UNITED STATES PATENT AND TRADEMARK OFFICE

APPLICATION NO.	FILING DATE	FIRST NAMED INVENTOR	ATTORNEY DOCKET NO.	CONFIRMATION NO.
10/807,350	03/24/2004	Frank Rosemann	A-10040	5378
181	7590	02/17/2006	EXAMINER	
MILES & STOCKBRIDGE PC 1751 PINNACLE DRIVE SUITE 500 MCLEAN, VA 22102-3833				CHAN, KO HUNG
ART UNIT		PAPER NUMBER		
		3632

Office Action Summary	Application No.	Applicant(s)
	10/807,350	ROSEMANN ET AL.
	Examiner Korie H. Chan	Art Unit 3632

DETAILED ACTION

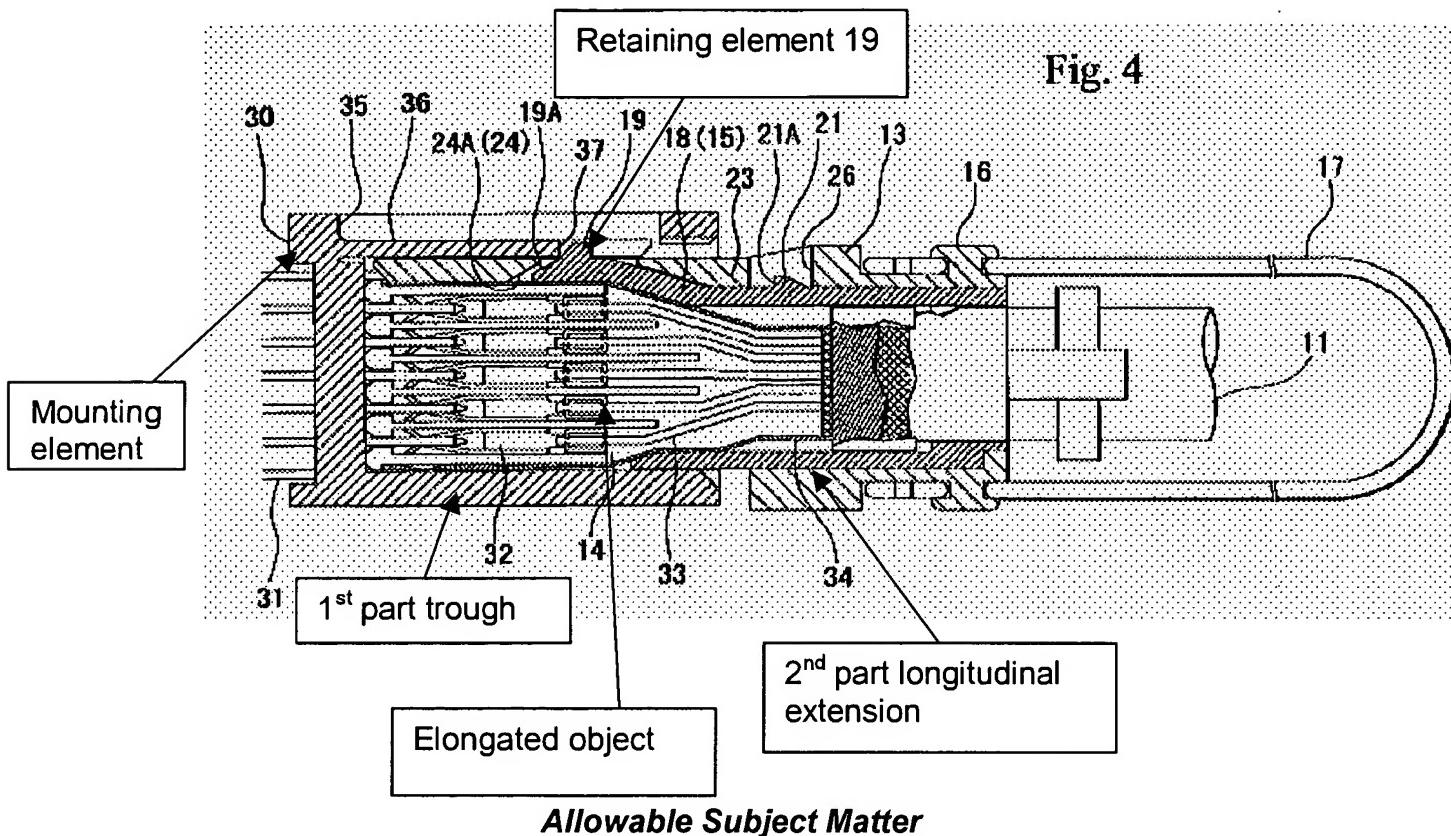
Claims 16-18 and 20 stands rejected under 35 U.S.C. 102(e) as being anticipated by Takahashi et al (US patent no. 6,447,170). Takahashi disclose a holder (see illustration below) for an elongated object, comprising: a first part (30) defining a trough (inner space) for receiving and supporting the object longitudinally along a longitudinal axis of the trough parallel to a bottom wall of the trough; and a second part (10) defining a longitudinal extension of the first part along the longitudinal axis for trough of also receiving and supporting the object longitudinally, wherein the second part is a slide constructed so that the second part of the first part along the longitudinal axis, and wherein the second part has a retaining element (see illustration below) that moves over the object (note the retainer 19 moves in a direction perpendicular to and over the elongated object during its snapping action into locking engagement with the first part 30) to hold the object on the holder in response to insertion of the second part into the trough of the first can be moved longitudinally into the trough part; wherein the retaining element is moved to a closed position by a wedging action as the second part moves into the trough of the first part; wherein the first part has a mounting element below its trough for attaching the first part to a substrate; wherein the first and second parts have cooperable fastening elements for fastening the second part to the first part upon insertion of the second part into the trough of the first part.

Applicant's arguments filed 12/8/2005 have been fully considered but they are not persuasive. Applicant first argues that Takahashi does not disclose a trough. Examiner disagrees. "a trough" is defined as "a long and narrow or shallow channel" in the MERRIAM-WEBSTER'S COLLEGiate DICTIONARY TENTH EDITION. Takahashi discloses exactly that a long narrow channel within the square cross-sectioned tube. Secondly, applicant argues that the cable 11 is already held in the connector 10 and is pushed into the housing 39 to lock and therefore does not constitute the retaining element move over the object on the holder in response to the insertion of part 10 into part 30. Examiner respectively disagrees. Takahashi's retaining element 10 is a snap

lock that moves above or over the cable 11 as it is snapped into the housing or second part 30 and consequently constitutes moving above (or over) the object in response to the insertion. Applicant has a different interpretation of what is actually claimed.
